Addendum #3

Re: Beaufort County Animal Shelter and Hilton Head Humane Association Animal Services Complex
Beaufort County, SC
10 Pritcher Point Road, Okatie, SC 29909
Bid Number: #041817E

This Addendum forms a part of the Contract Documents and modifies the original drawings and specifications dated 03/02/2017. Contractor shall be responsible to review changes to all portions of the work as changes of one portion may affect the work of another. Contractor shall indicate receipt of this addendum on the bid form.

DRAINAGE DETAILS

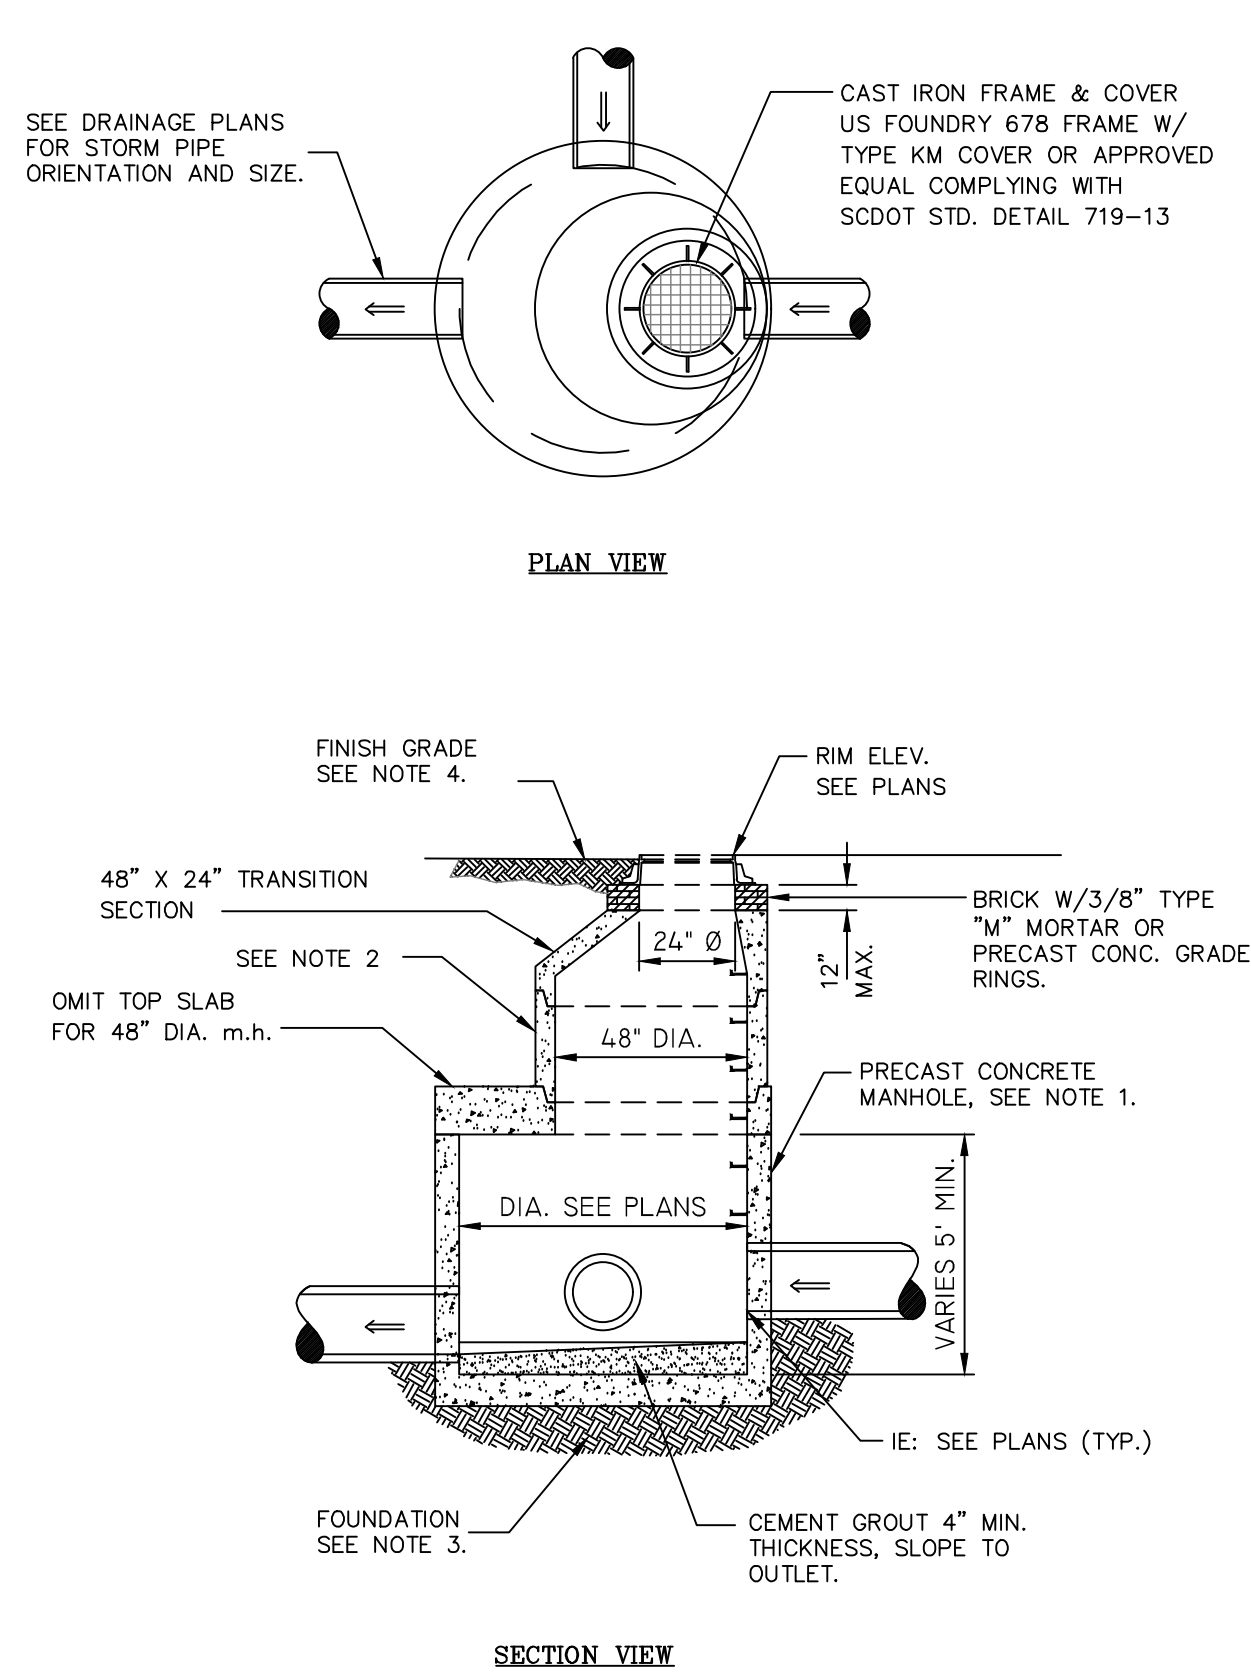
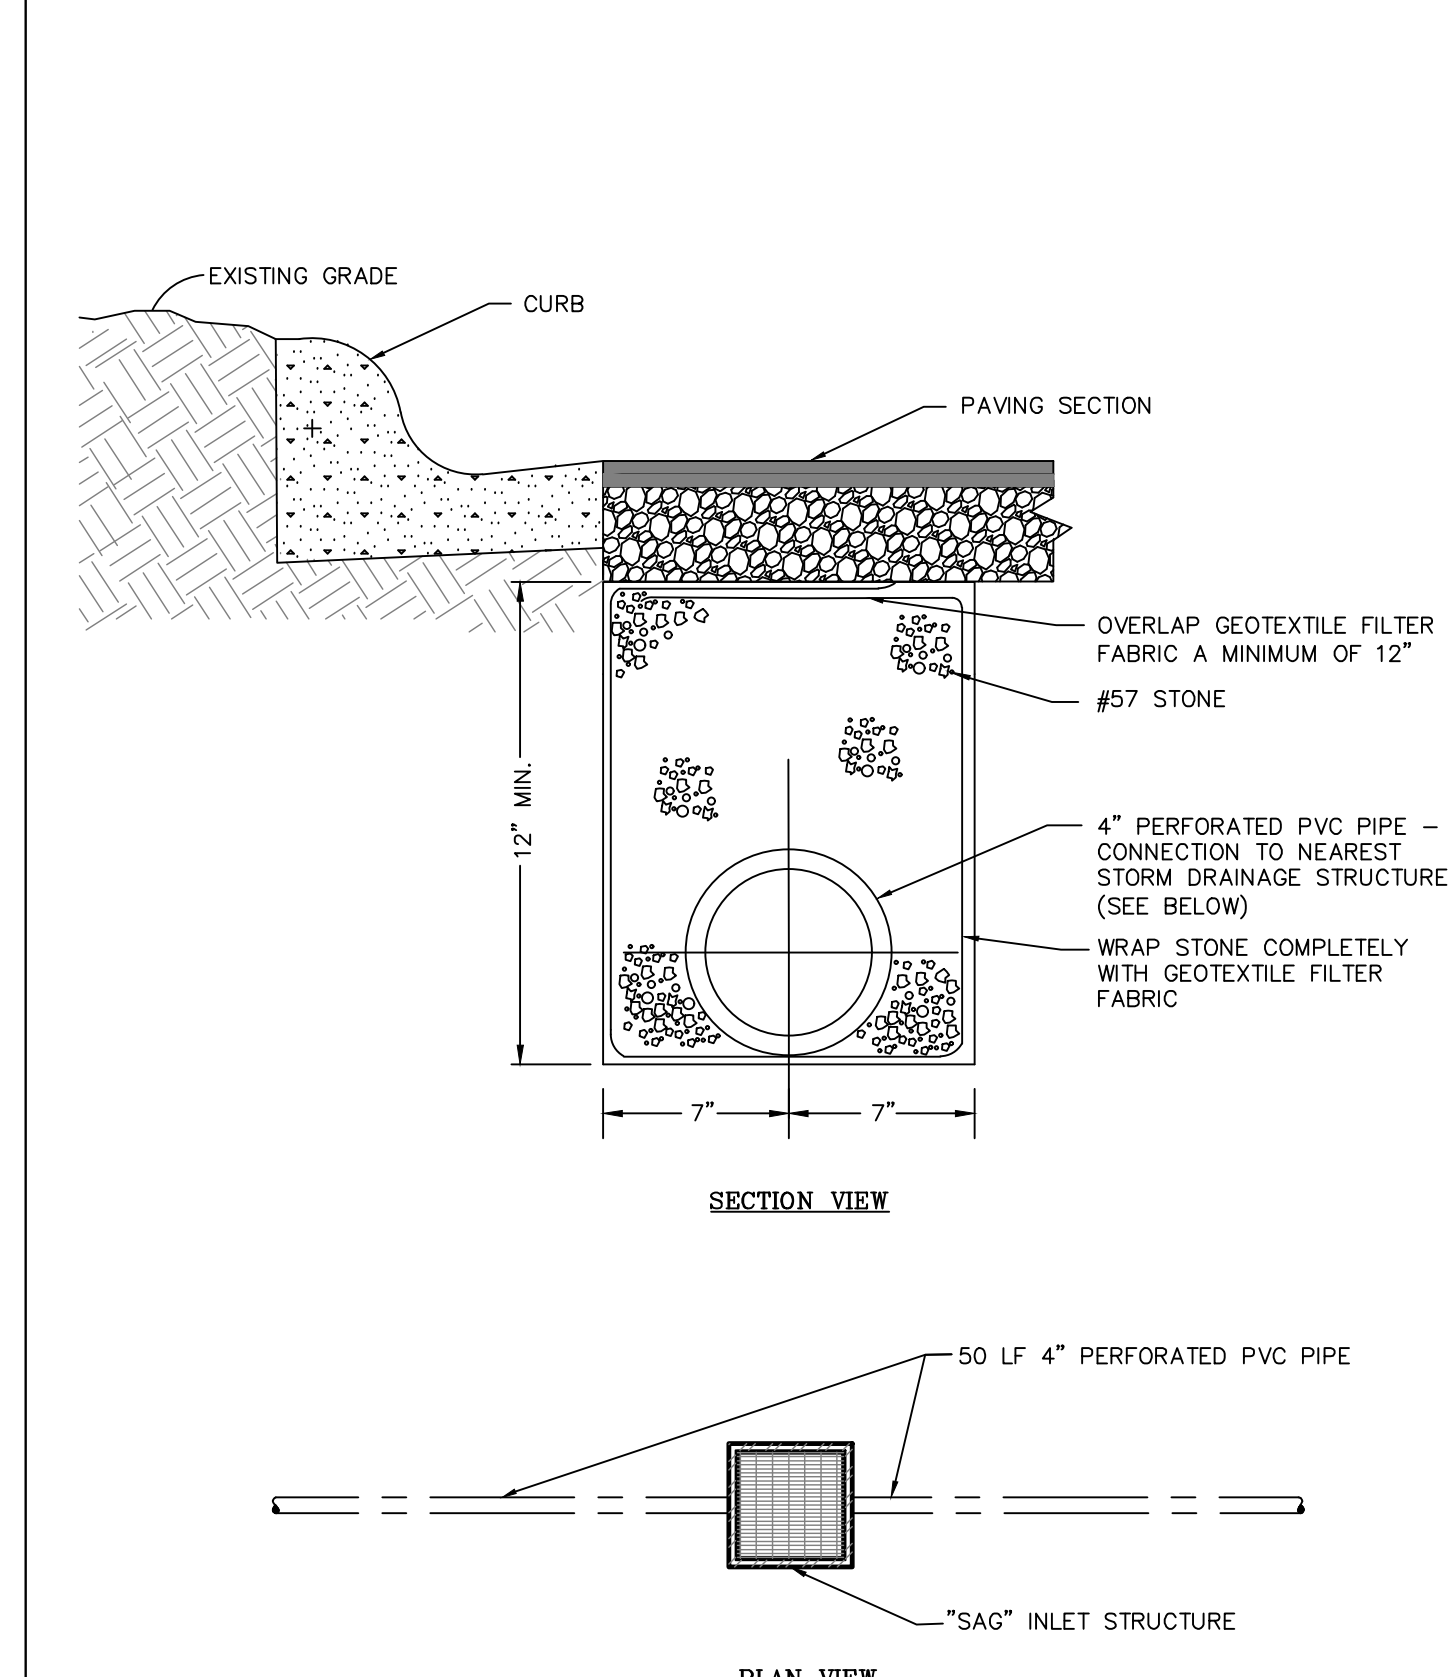
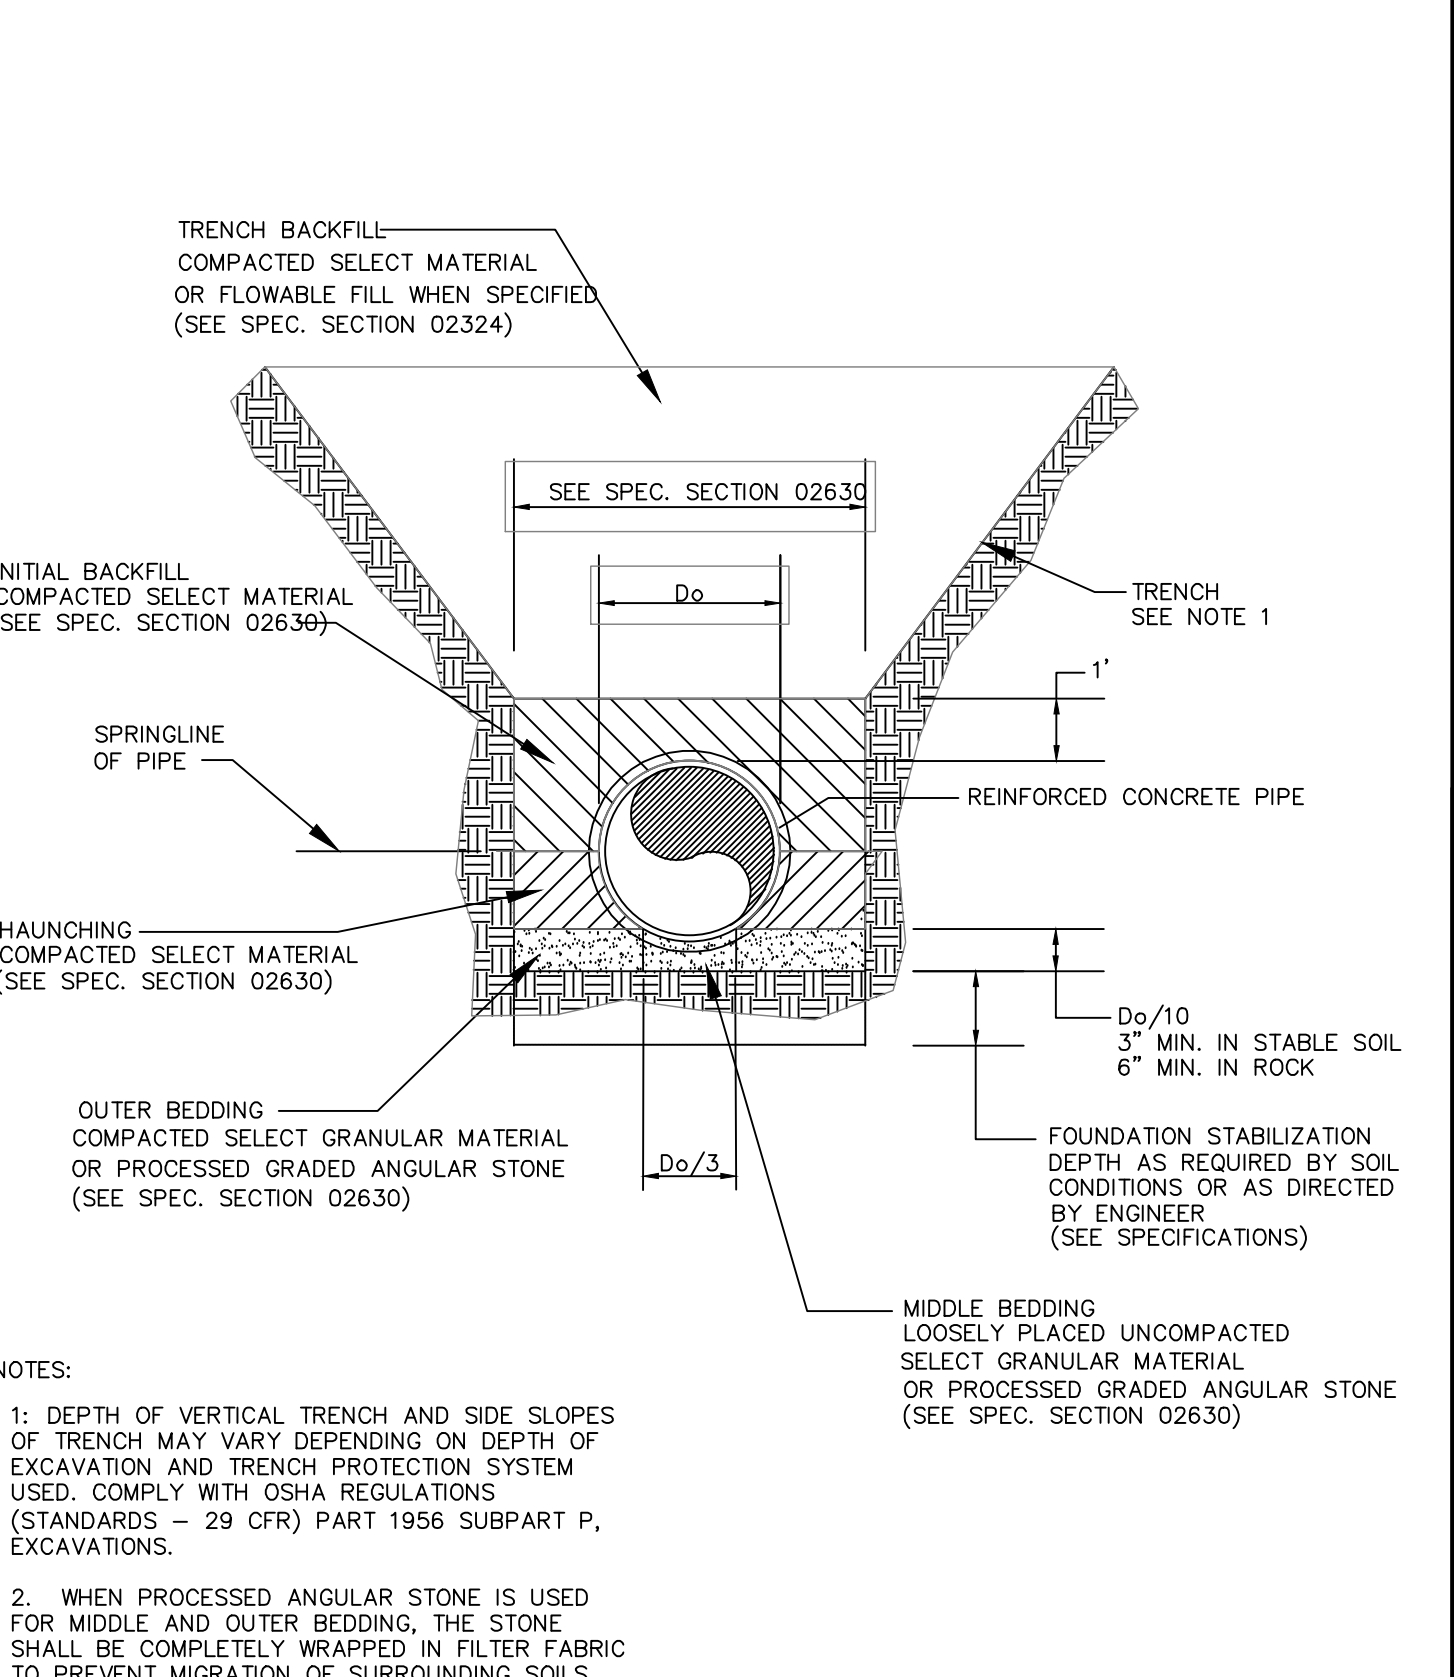
1. Revise the underdrain detail to add the location of the underdrains.
2. Refer to attached Sheet.
